ASSESSMENT REPORT

WENONA SCHOOL SSD 6952 MOD 1

Figure 5: Northern Elevation - approved (top) and proposed (bottom)

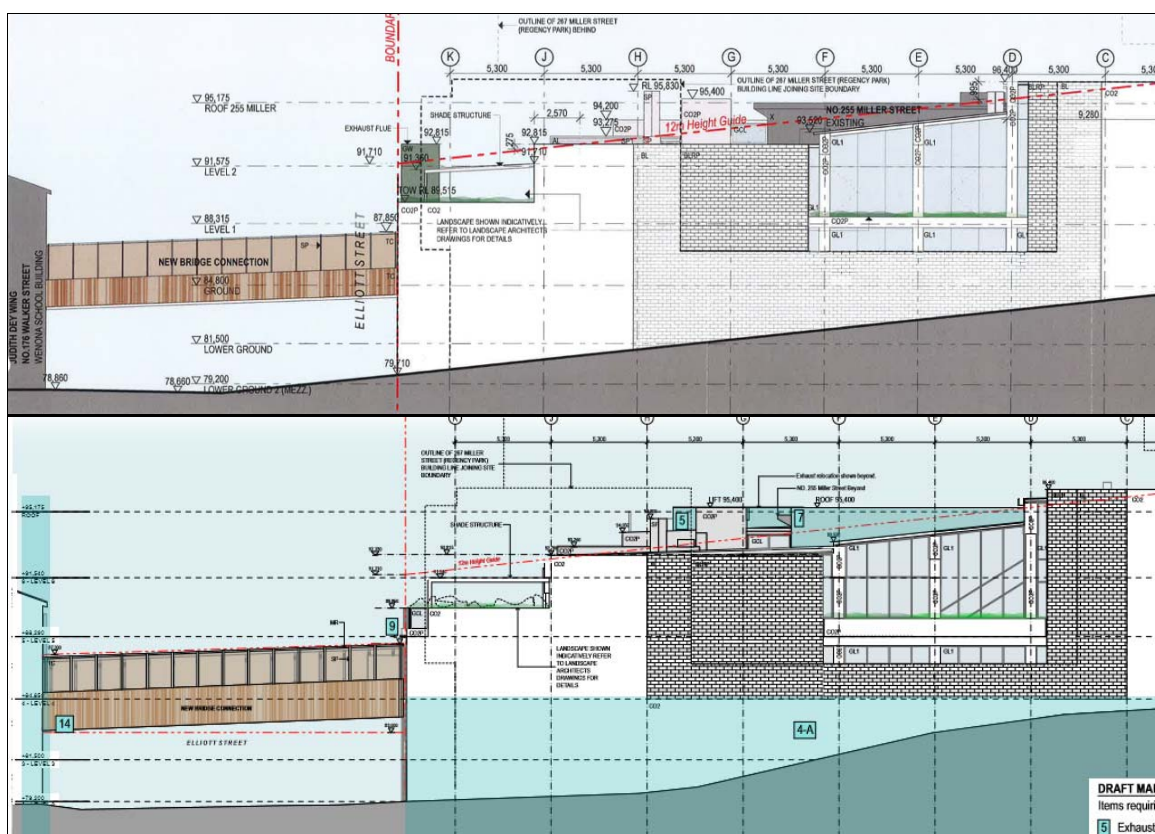
Proposed Modification	
External	<ul style="list-style-type: none"> relocate the vertical exhaust riser from the eastern side of the building to the southern side of the building; change the 1.1 m high concrete balustrade on the eastern elevation facing Elliot Street with a 450 mm high concrete planter and 1.1 metre high glass balustrade above; reduce the extent of glass louvers over the timber balustrade on the western elevation facing Miller Street; add doors to the fire hydrant booster system at the western elevation facing Miller Street;

<ul style="list-style-type: none"> remove two awnings above the rooftop terrace; increase in the footprint of the plant room on the roof by 40 sqm; reconfigure the terrace gardens on Levels 3 and 5; add a rainwater tank to Level 5 of the terrace garden; modify the shape of the glass roof; provide a roof connection between the existing building to the south at 255 Miller Street and the approved building; adjust the location of the bike racks and garbage storage at Level 2; relocate the roof cowl and kitchen exhaust on the roof; remove a window at the southern elevation adjacent to the chemical storage room on Level 3; replace the timber cladding on the southern side of the pedestrian overpass with metal cladding;
<i>Internal</i>	<ul style="list-style-type: none"> minor reconfiguration of the internal layout relocate plant and the inclusion of additional toilet facilities; relocate the pool exhaust from the eastern part of the basement to the southern end of the basement; provide additional mechanical trenching in the basement to accommodate in-ground services; adjust the floor to floor ceiling heights on Levels 4 to 6 based on revised survey information; relocate the On-Site Detention (OSD) tank from under the pedestrian overpass to the southern end of the site; and confirm details of shoring and underpinning along site boundaries.
